Norfolk Boreas Offshore Wind Farm

Statement of Common Ground

Norfolk County Council

Applicant: Norfolk Boreas Limited
Document reference: ExA.SoCG-19.D2.V1
Deadline 2
Date: December 2019
Revision: Version 1
Author: Royal HaskoningDHV

Figure 1. Location of Access A, B and D1 on the A47 at Necton

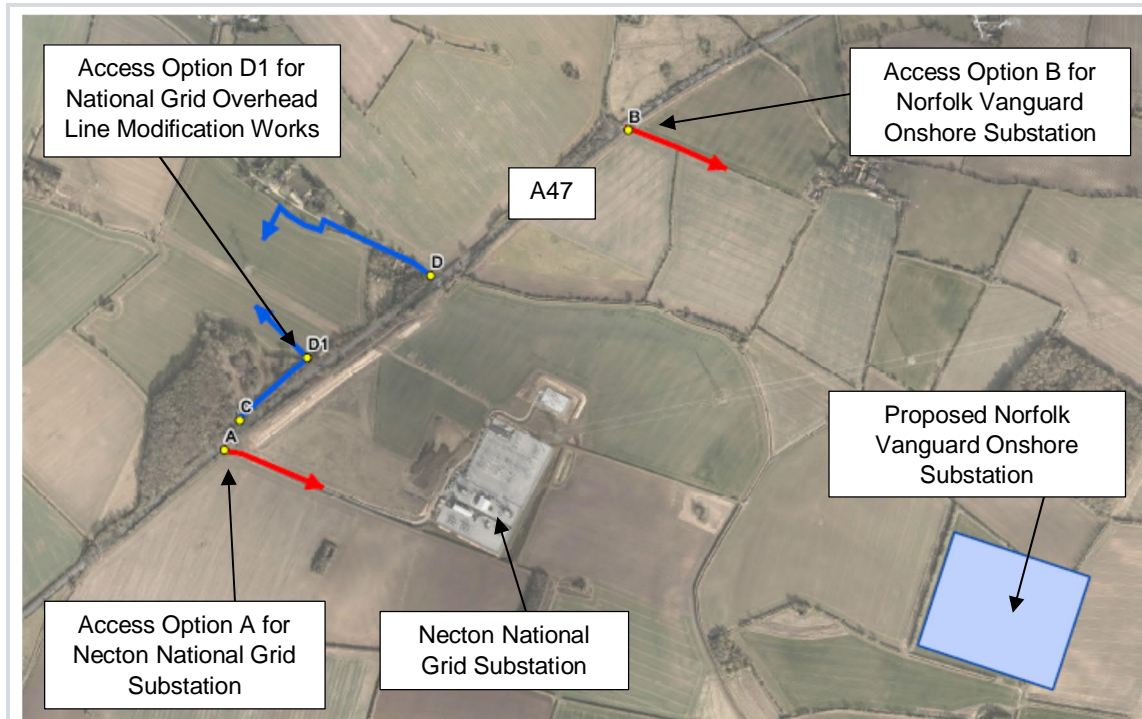
11. The SACTN contains a statement that *'Increasing the 'x' distance to 4.5m would require the removal of a large proportion of established hedgerows, vegetation and trees. This will have ecological impact and would remove much of the native mature screening required to mitigate the landscape impact'*. In the circumstances, this appears to be sufficient grounds to permit what is effectively a two-step permitted relaxation in the provision of emerging visibility at access point B.

13. On that basis, the layouts currently offered for access points A, B and D1 appear satisfactory, subject to:
- visibility splays being cleared of foliage;
 - visibility being proven in the vertical plane;
 - the implementation of the traffic management measures proposed; and
 - the carrying out of Stage 1 and 2 Road Safety Audits.

15. The updated layouts, traffic management arrangements and traffic flows presented in the SACTN provide sufficient confidence to allow AECOM to advise Highways England that they could now form the basis of an updated Statement of Common Ground indicating Highways England's agreement in principle with the access arrangements proposed.

Figure 1. Location of Cable Crossing sites and proposed access routes

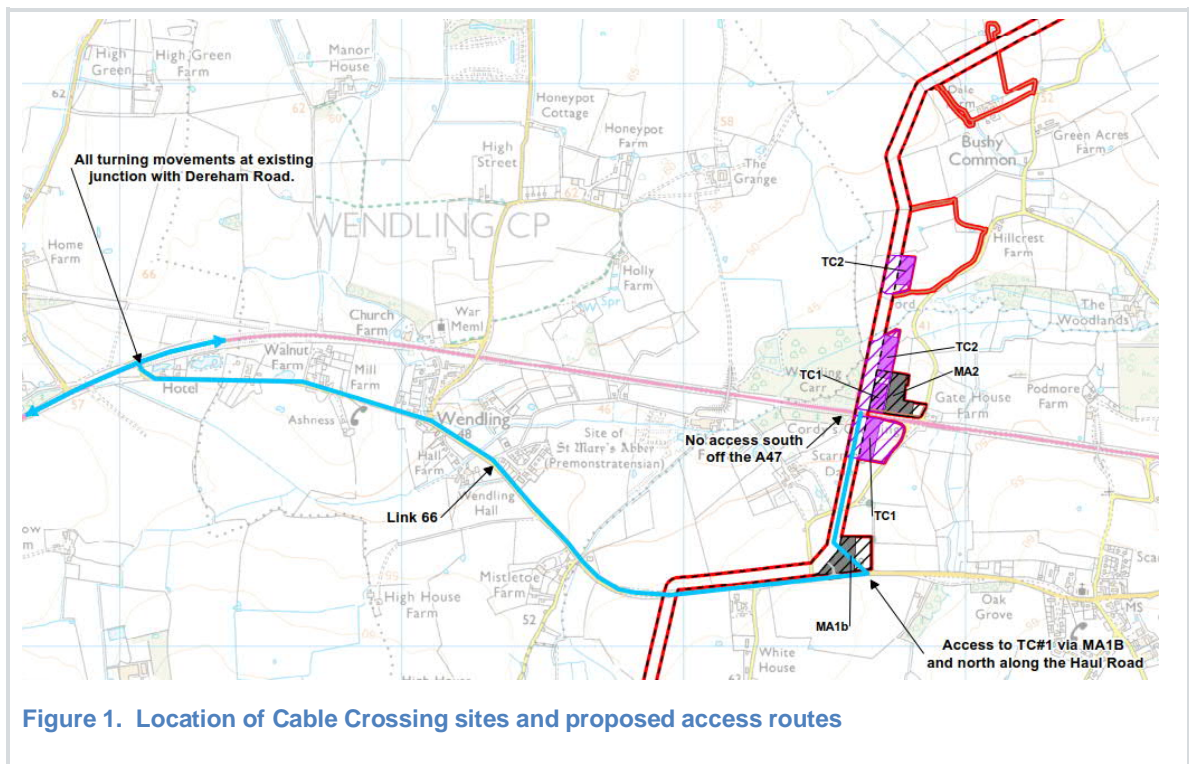
15. The layout of site access junction AC160 illustrated on Drawing PB4476-DR025 D0.1 appears to provide satisfactory geometry to accommodate heavy vehicles turning to and from the A47. There is no suggestion that the use of this junction by vehicles accessing the works would give rise to a queue of stationary traffic within Bushy Common Road waiting to enter the site, such as would risk generating a queue of traffic back to the A47, some 50m away.

17. The visibility splay to the right illustrated for the site access junction appears to provide visibility from an x-distance of 2.4m back into the minor arm all the way to the A47, some 50m away. Whilst this does not strictly comply with the requirements of TD41 Table 2/1, a visibility splay as far as the preceding junction should in practice be adequate to allow the driver of a vehicle emerging from the site access to see a vehicle approaching from the A47 at up to 30 mph. Speeds around the 15m corner radii between the A47 and Bushy Common Road are likely to be less than this. The relaxation of the X distance from 4.5m to 2.4m would be permitted in this location (TD41 para 2.21 refers).

19. The layout of the improved junction between the A47 and Bushy Common Road, illustrated on Drawing PB4476-DR025 D0.1, appears to provide in full for the requirements of DMRB Design Standard TD42 for this type of junction. In addition, the swept path plots shown on Drawings PB4476-DR026 and 027 show that it can accommodate heavy vehicles turning on and off the A47 without clipping kerb lines, and without encroaching on the wrong side of the A47 or the minor road.

21. Whilst the visibility splays have not been proved in the vertical plane, the local topography is generally flat, although there appears to be a slight rise towards the back of the verge on the north side of the A47 to the west of the junction and this should be addressed as the design of the junction progresses. AECOM note that the land behind the highway verge lies within the red line boundary of the development and it is therefore within the power of the Applicant to address any problems.

30. The updated layouts, traffic management arrangements and traffic flows presented in the CCATN provide sufficient confidence to allow AECOM to advise Highways England that they could now form the basis of an updated Statement of Common Ground indicating Highways England's agreement in principle to the access arrangements proposed.
